Subject: Environmental Impact Statement for Waimanalo Agricultural  
Park, Phase I, Waimanalo, Oahu

FINAL ENVIRONMENTAL IMPACT STATEMENT

Project: Agricultural Subdivision  
Phase I Increment for the Waimanalo Agricultural Park

**Figure 3-3**  
 PRELIMINARY SUBD  
 WAIMANALO AGRICULTURA  
 SUBDIVISION OF A PO  
 THE GOVERNMENT LAND OF K  
 INTO LOTS 1 TO 15, INC  
 AT WAIMANALO, KOOLAUPOK  
 OWNER: STATE OF

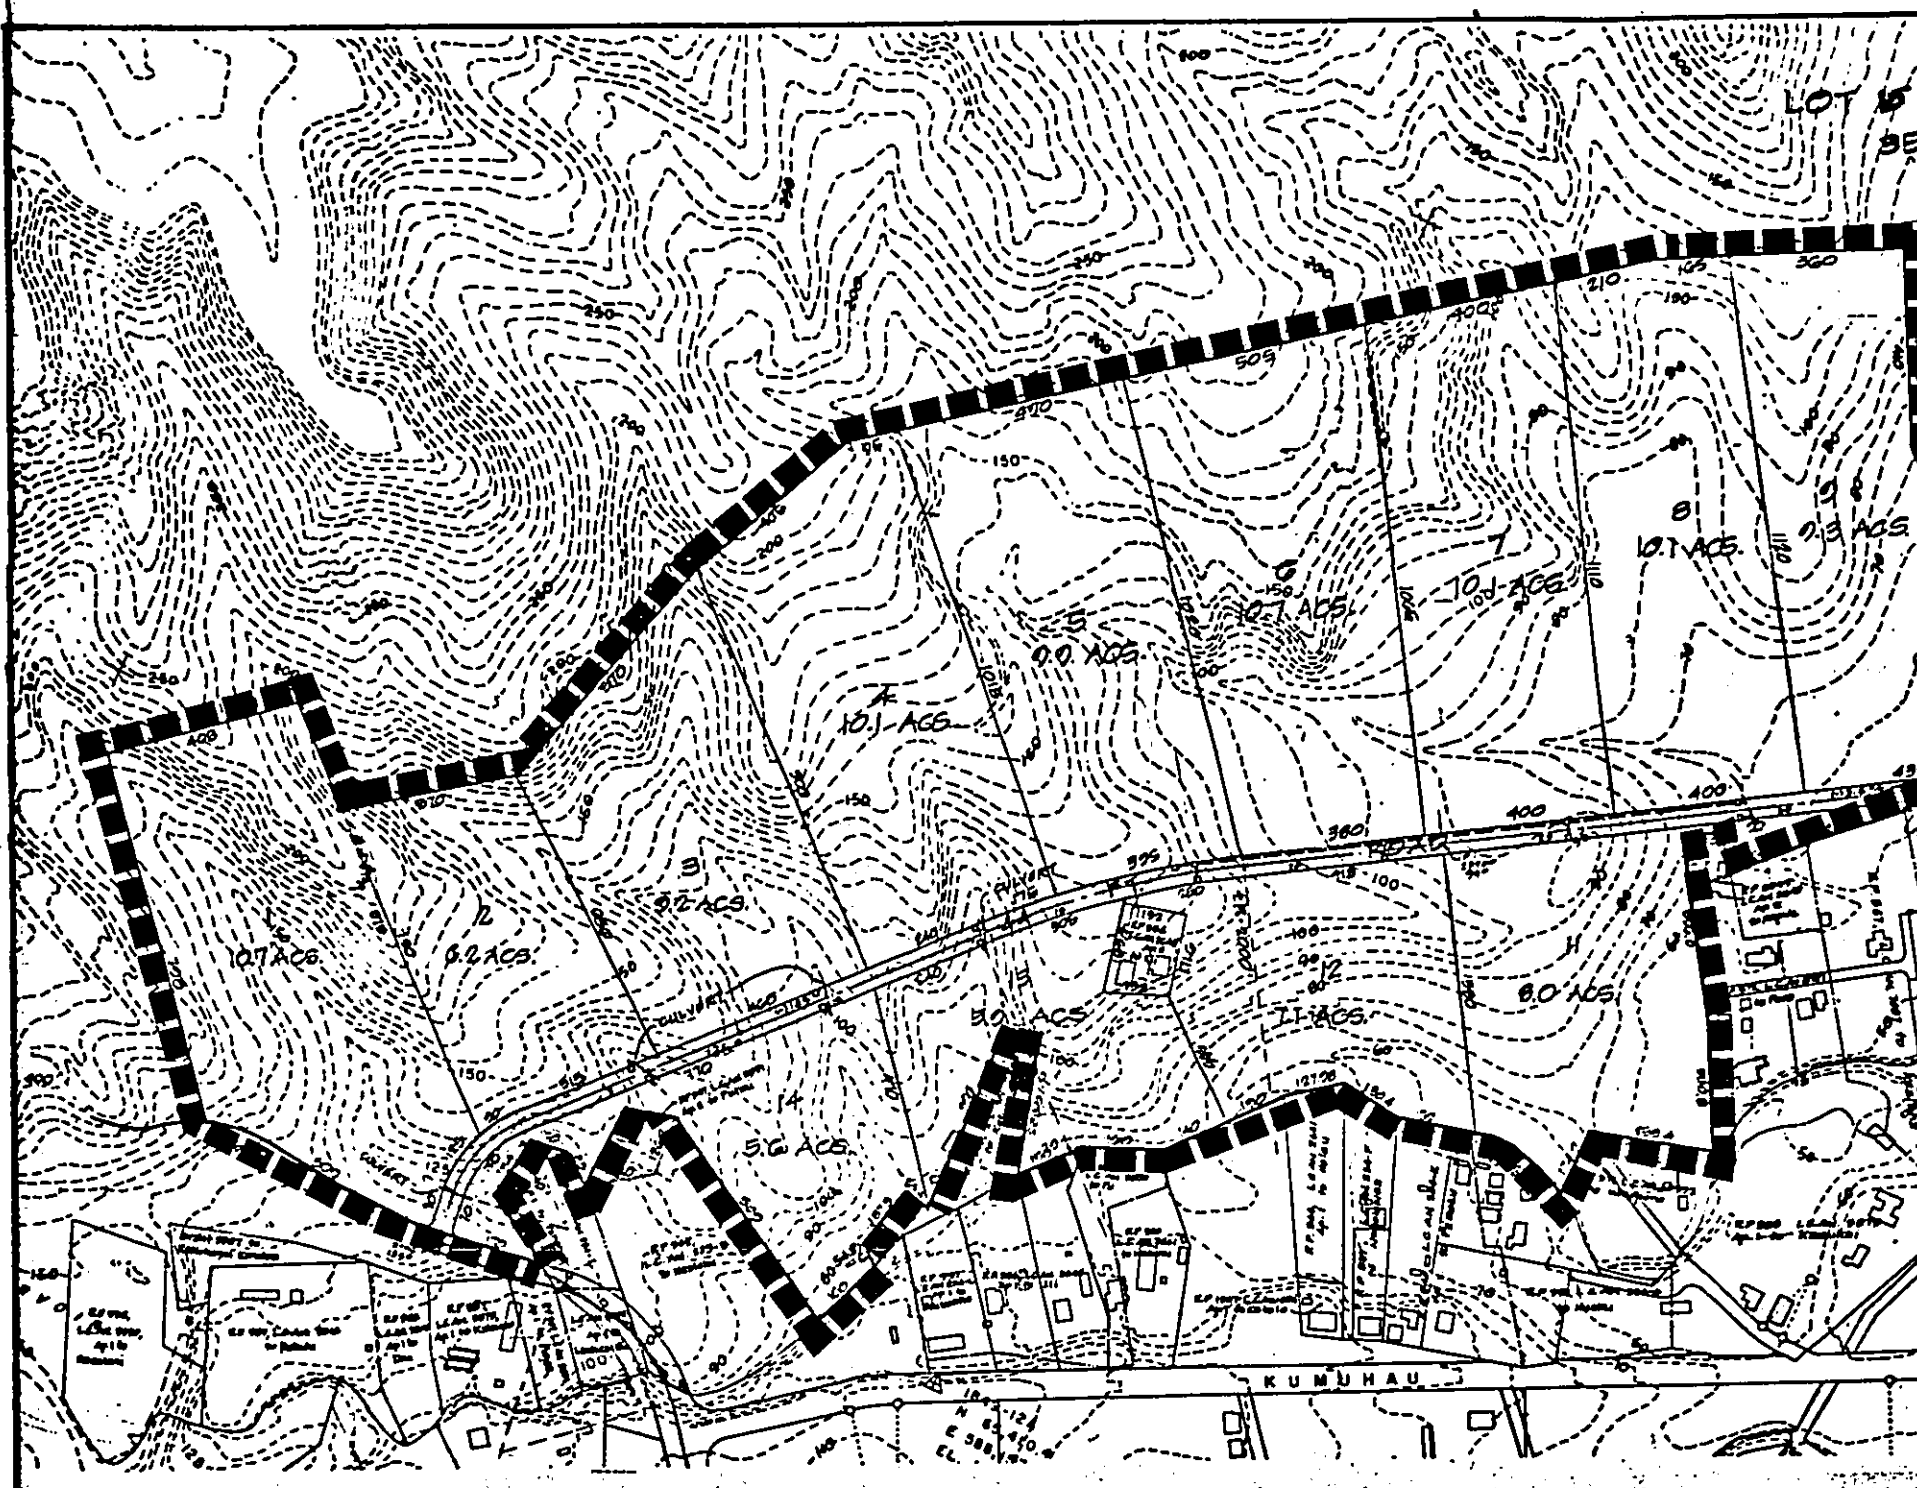
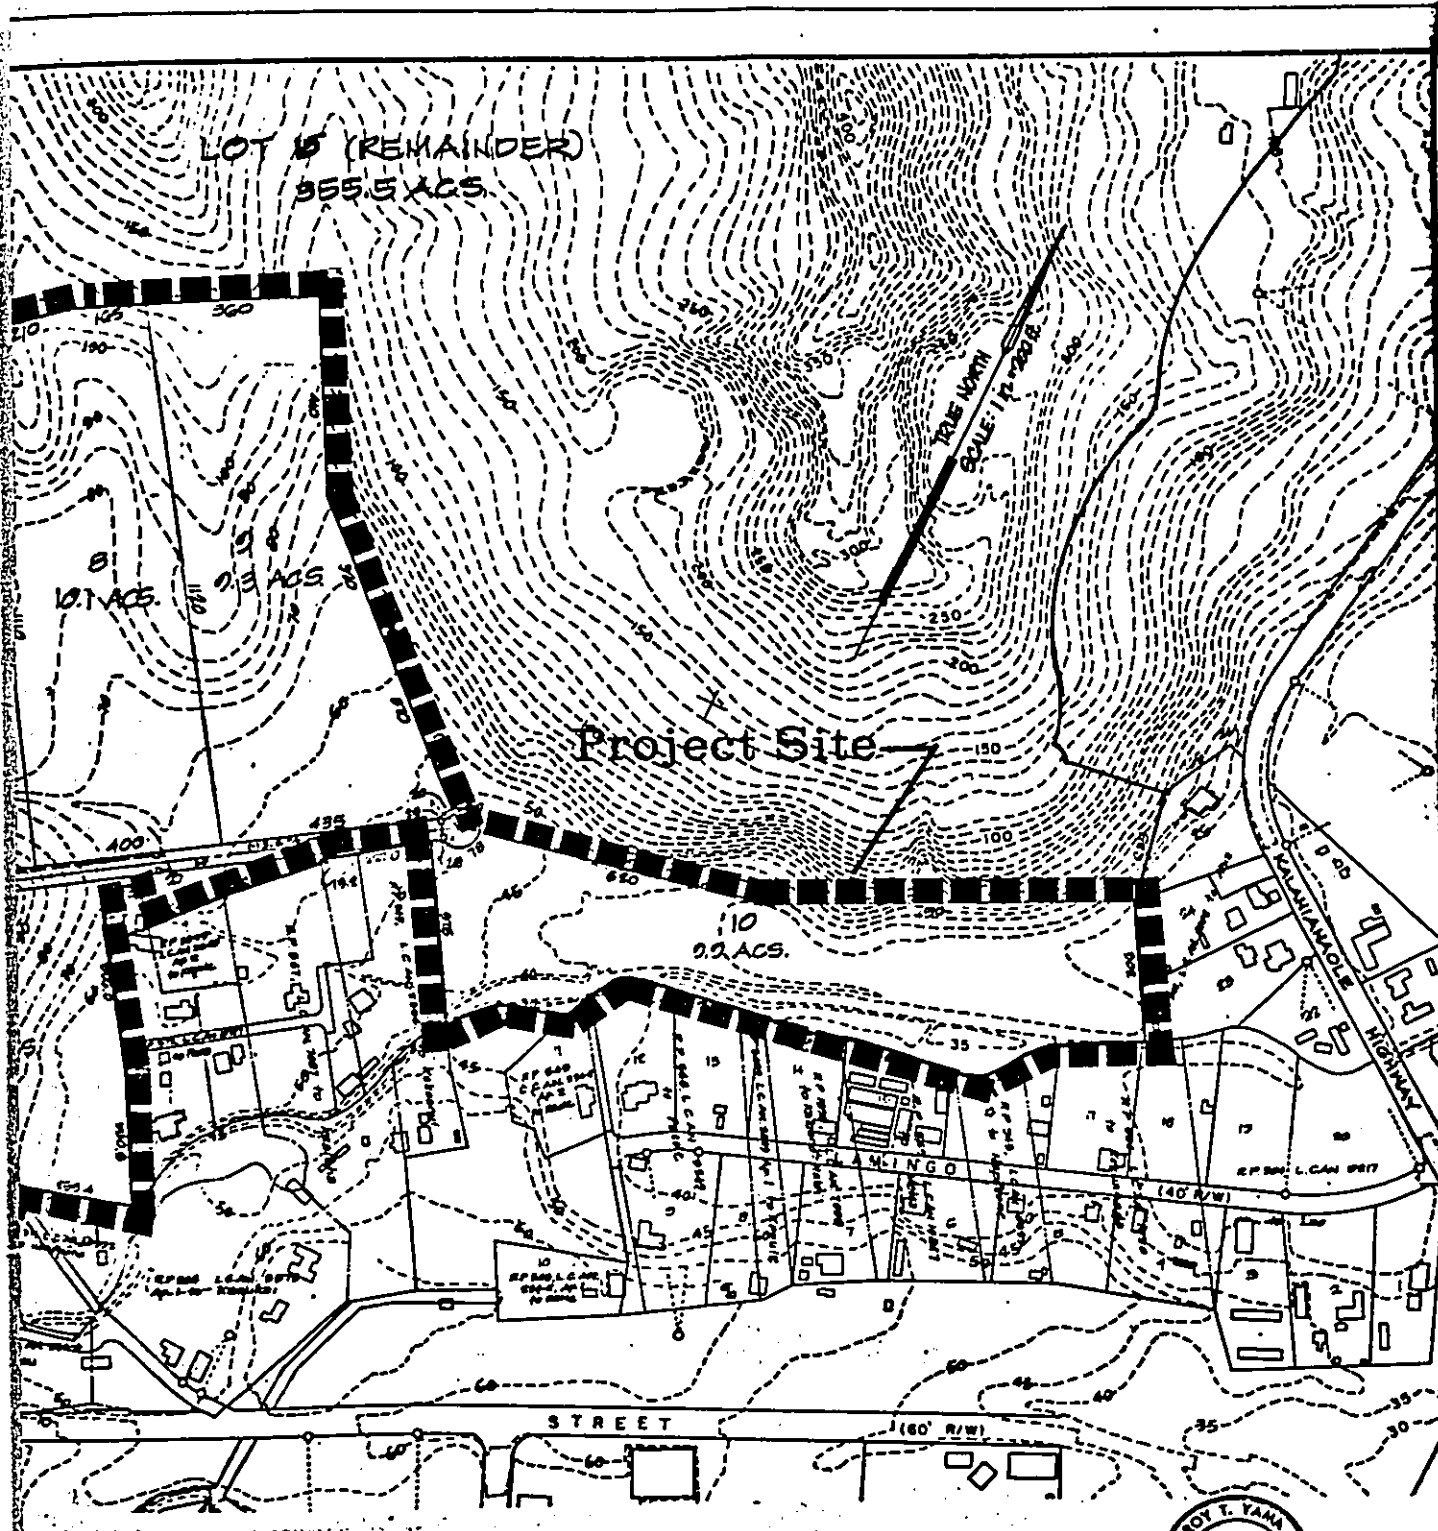
In view of the concern of the Oahu Banana Growers Association over the size of the lots designated for banana production (see my letter of December 23, 1981, copy of which has previously gone to you), Section 3 should indicate the intended use of each of the lots shown in Figure 3-3, as well as the rationale for the lot size chosen for each use category.

Figure 3-3, on page 3-4, presents the 15 lots and the internal roadway. Figure 4-2, on page 4-6, presents the Waimanalo Stream in relationship to the project site, Waimanalo Watershed and Drainage Basin. Regarding the irrigation system, the consulting engineers are currently finalizing drafts of the appurtenance. You will be welcomed to view them upon completion.

In view of the concern expressed by you, we reexamined the lot layout of the proposed agricultural park and replotted a portion of the layout. Figure 3-4 shows the revised lot layout which eliminates two cul-de-sacs and rearranges eight lots (lots 4 through 11) into six lots, each approximately ten acres in size. The original eight lots consisted of 3- to 5-acre lots, four lots ranging in size from 7.9 to 9.3 acres and one 10.7 acre lot. The advantages of the new revised layout are:
